MONITORING YEAR 2 ANNUAL REPORT

BIG HARRIS CREEK MITIGATION SITE

RE: Big Harris Creek Mitigation Site – Monitoring Year 2 Report
Final Submittal for DMS
Contract Number 006256, RFP Number 16-006119, DMS# 739
Broad River Basin – CU# 03050105; Cleveland County, NC

Wildlands Engineering, Inc. (Wildlands) has reviewed the Division of Mitigation Services (DMS) comments and observations from the Big Harris Creek Mitigation Site Draft Monitoring Year 2 Report. The following are Wildlands' responses to your comments from the report noted in *italic lettering*.

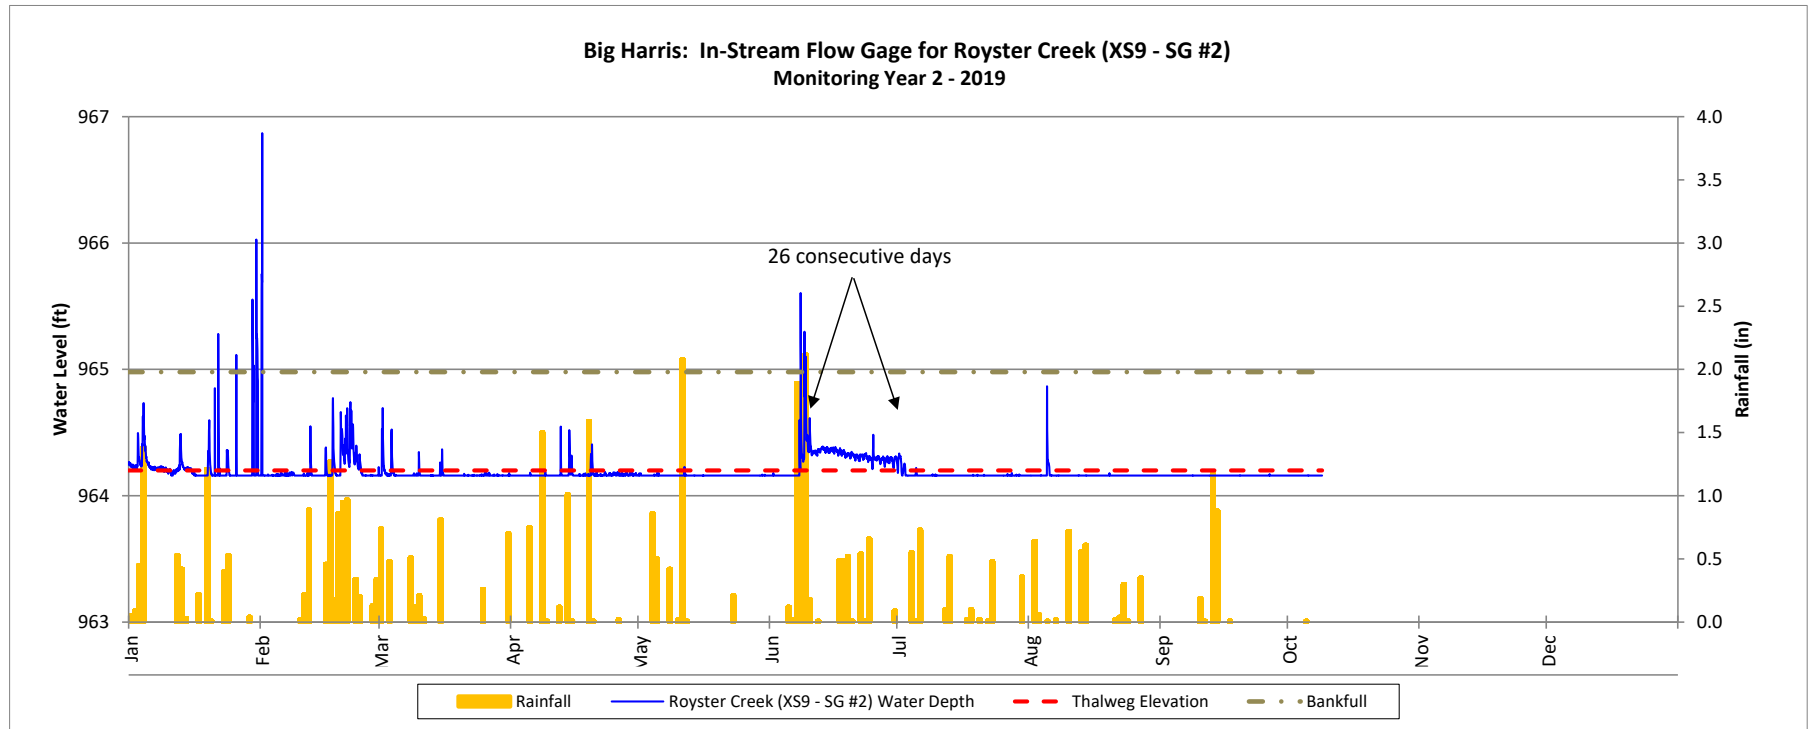
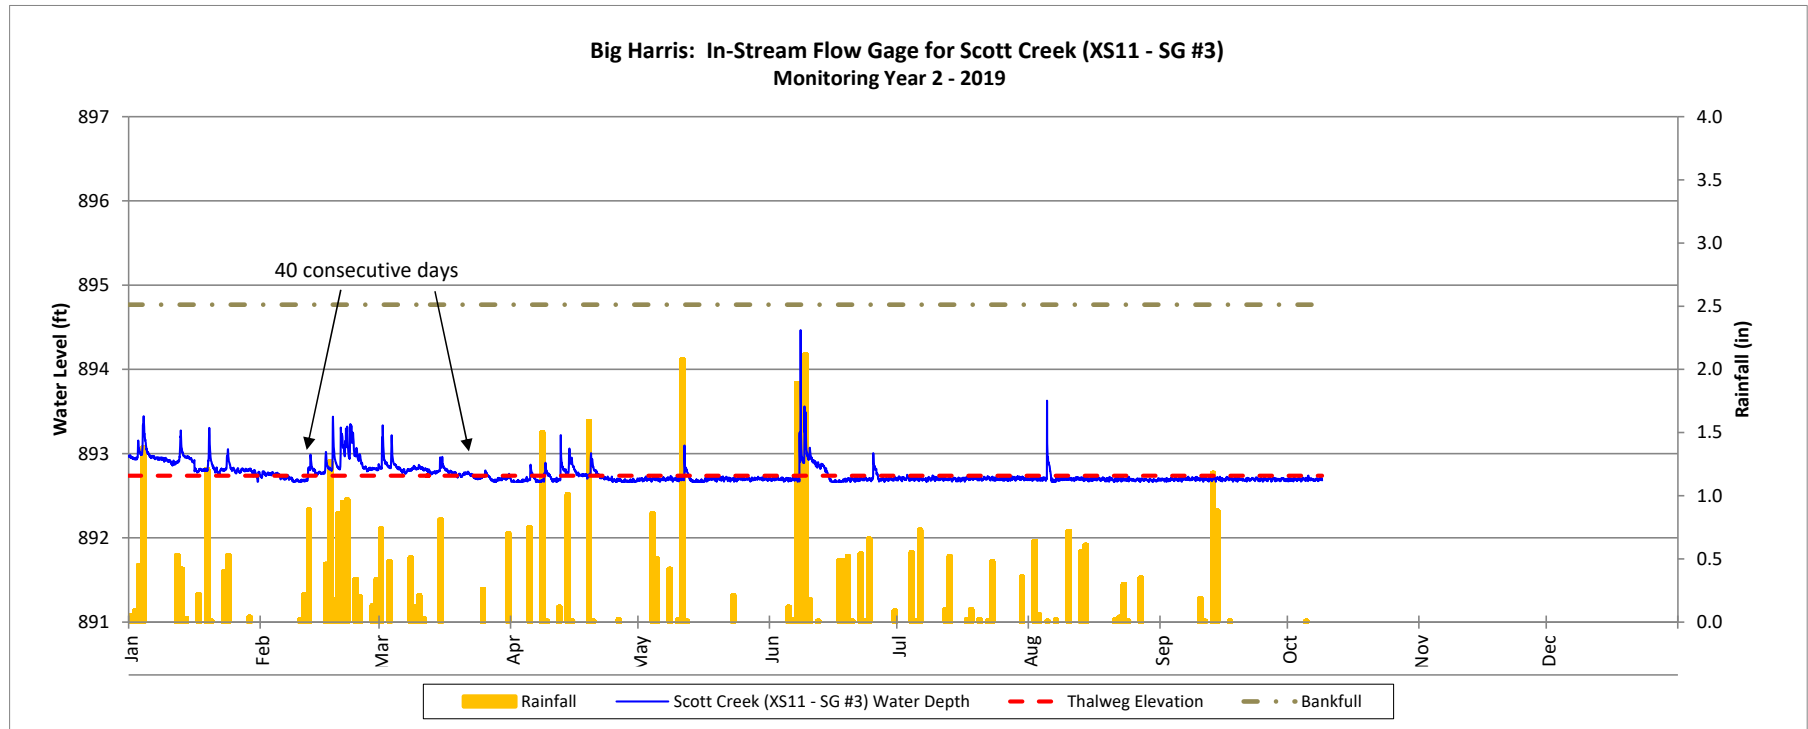
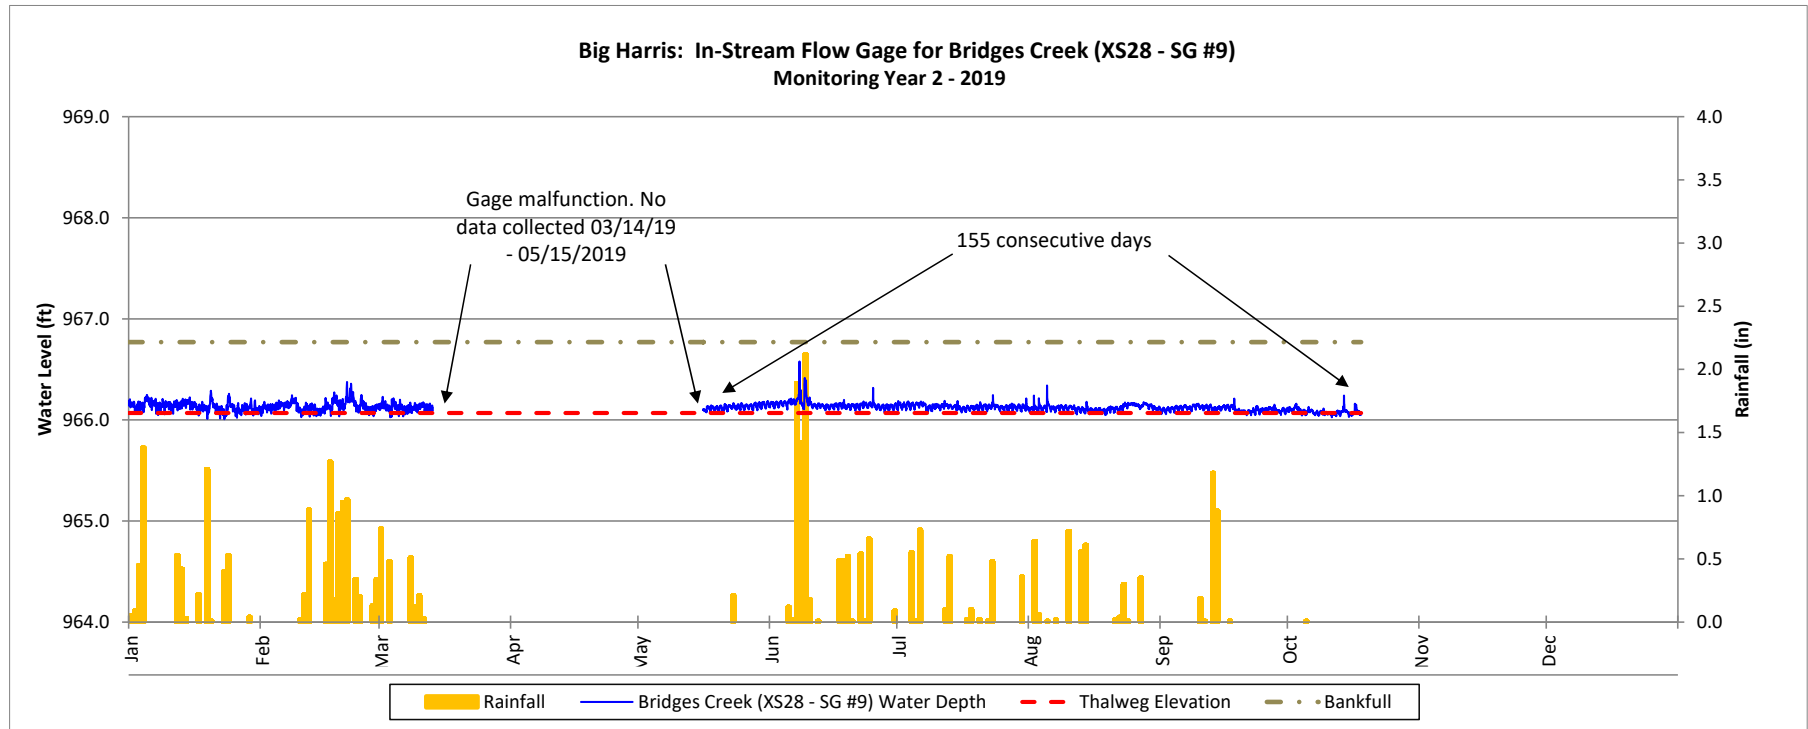
DMS Comment; Appendix 5 – In-Stream Flow Gage Graphs: Please add a start and finish callout/ arrow for the maximum days on each graph.

Wildlands Response; Arrows have been added to the In-Stream Gage Graphs to denote the start and finish for the period of maximum days on each graph.
